SUBJECT: **Conditional Use Permit, Site Plan Review, Adjustment Driveway Approach Permit and Design Review Case No. CU-SPR-DAP-DR21-05 – 4900 Block of State Street – 97301; Supplemental Staff Report**

On January 24, 2022, the applicant submitted an updated site plan (Sheet SDR3) and building elevation plans (**Attachment A**). On January 26, 2022 the applicant submitted an updated written response. The following is a staff response to the applicant's updated plans and findings (**Attachment B**).

EAST PARK APARTMENTS

SDR3

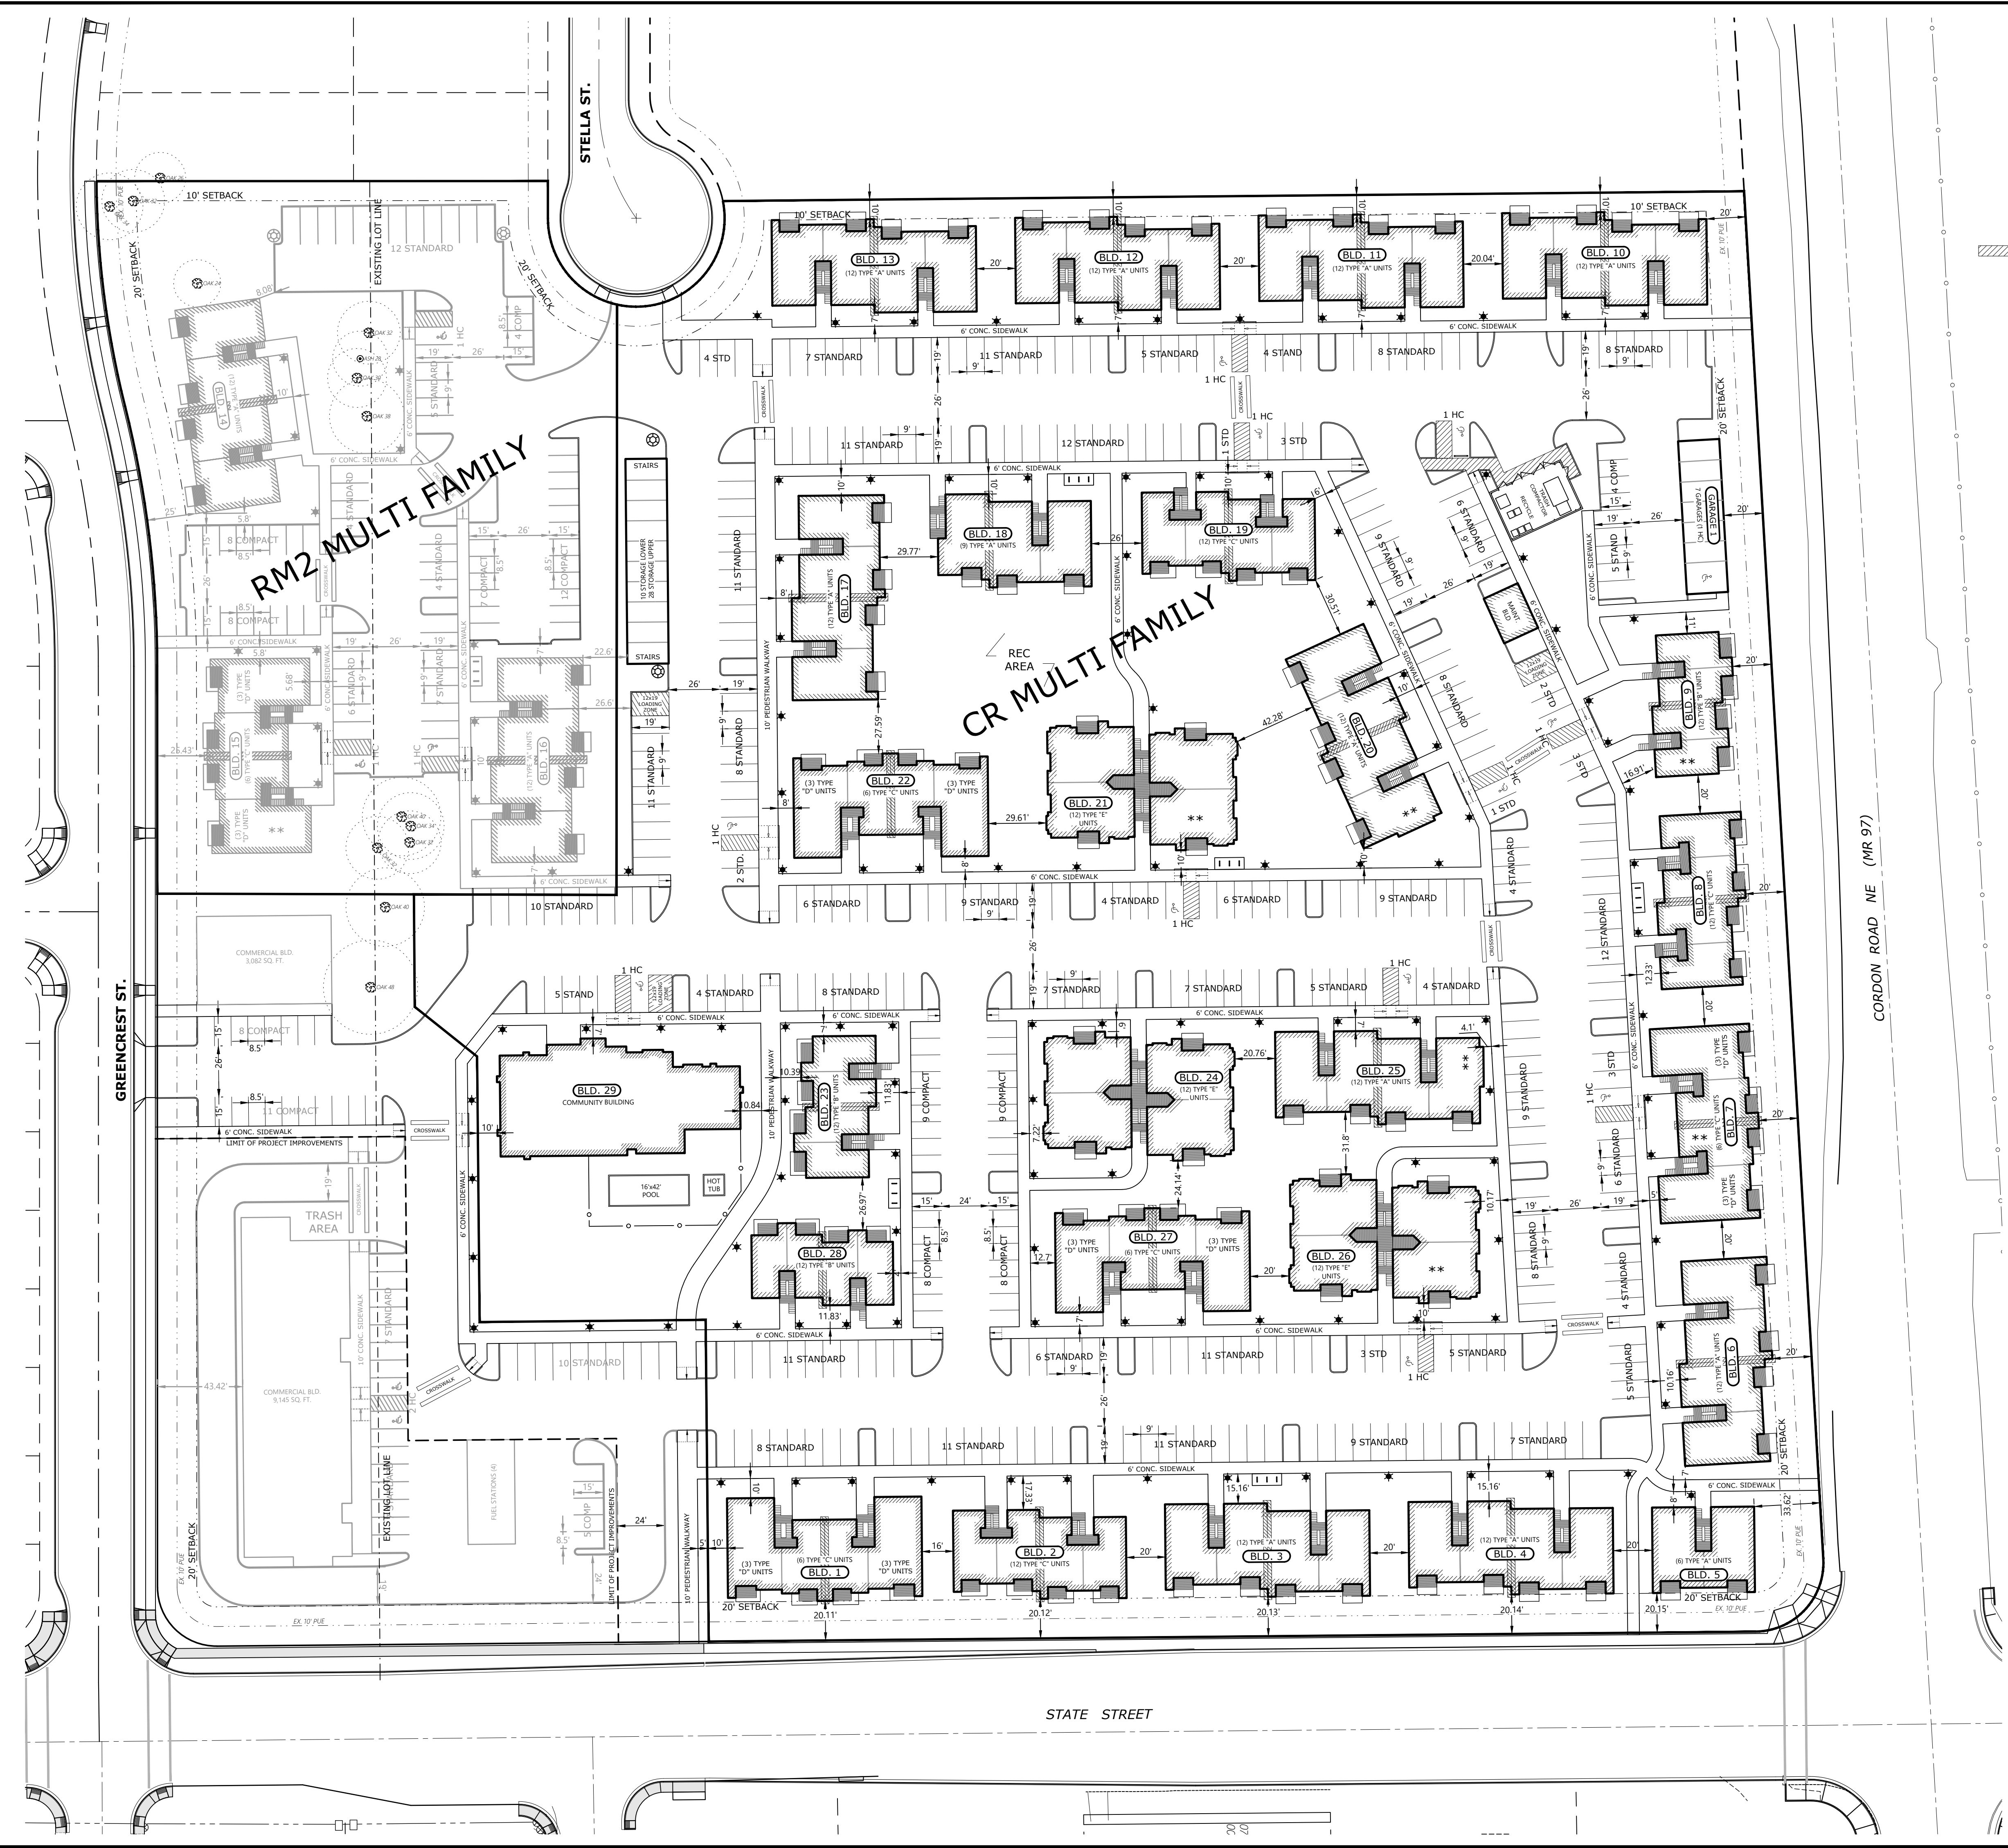
a. Driveway to State Street has been removed.

The site plan provided for the December 22, 2021 hearing included a driveway approach with direct access to State Street. State Street is classified as a major arterial in the Salem Transportation System Plan, and the minimum driveway spacing standard between driveway approaches or intersection is 370 feet per SRC 804.035, the proposed driveway was approximately 275-feet from the intersection of Greencrest Street NE, and did not comply with minimum standards. The driveway has been removed. Primary access for the proposed multi-family use is now from Greencrest Street NE and secondary access is provided by Stella Street NE, however Stella Street NE will not be constructed until Phased 5 of the East Park Estates Planned Unit Development.

The Fire Department will require a minimum of two approved points of access for the apartment complex. Greencrest Street NE is scheduled to be complete with Phase 3 of the East Park Estates Planned Unit Development and Stella Street NE is scheduled to be complete with Phase 5. If the Hearings Officer approves the proposed multi-family development, Stella Street NE may be constructed later than the multi-family development, the applicant will need to provide a means for secondary access to the site, which may mean construction of Stella Street NE prior to Phase 5.

- b. A pedestrian pathway has been added on the east side of buildings 23 and 28.

The site plan provided for the December 22, 2021 hearing did not include a pedestrian connection on the east side of buildings 23 and 28. A pedestrian connection between the adjacent parking area and building entrance is required per SRC 702.020(d)(4). The applicant's updated site plan provides this missing pedestrian connection, staff has no further concerns.

- c. Adjusted bicycle parking location.

The site plan provided for the December 22, 2021 hearing showed required bicycle parking spaces in a location that was further than 50 feet from a primary building entrance, and therefore not in compliance with the bicycle parking location standards in SRC 806.060(a)(1). The applicant's updated site plan shifted the location of the bicycle parking space near Building 21 in a location within 50 feet of a primary building entrance consistent with the standards in SRC 806.060(a)(1), staff has no further concerns.

- e. Applicant has updated the site plan showing a new line to measure setbacks between the proposed multi-family use and a future commercial use.

The site plan provided for the December 22, 2021 hearing included a shared drive aisle between the proposed multi-family use and a future commercial use in the southwest corner of the property. Staff had previously noted that a shared drive aisle is not allowed to be located across the common property line separating the two uses and had also expressed concerns with compatibility between the multi-family use and a future gasoline service station and convenience store.

The updated site plan changes the location where the setback is measured but does not explain if the property line is shifting to this new location, to add to the

confusion, the line identifying the limits for the project seem to include development of drive aisles and parking spaces for the future commercial use. If the property line is shifting to the new bold line, then the multi-family use is required to have a minimum 10-foot wide landscaped setback per Table 522-3 meeting the Type C standard set forth in Chapter 807 along this line. In addition to landscaping, the Type C Standard includes the requirement for a six-foot-tall fence or wall. The applicant does not indicate how fencing will be provided for the site. Fencing could further complicate pedestrian access from the site to Greencrest Street and State Street. Provisions for access easements across the future commercial property and the proposed multi-family use are also not addressed on the updated site plan.

Staff's concern regarding compatibility has not been addressed with the revised method for measuring the required setbacks between uses. The update site plan continues to provide shared vehicle access between the proposed commercial use and the multi-family use while further limiting pedestrian access to the multi-family use.

The shared driveway from State Street has been eliminated. The enclosed site plan illustrates the new design. The rows of parking on the residential property that the staff report objected to are now either eliminated, or on the commercial property because the boundary between the residential and commercial uses has been moved north and east.

On the prior site plan, one of the bicycle parking pads with required bicycle parking spaces was located between buildings 20 and 21, more than 50 feet from a primary building entrance, and therefore not in compliance with SRC 806.060(a)(1). That pad has been shifted toward the west on the new site plan, to be less than 50 feet from the Building 20 entrance. This standard is satisfied.
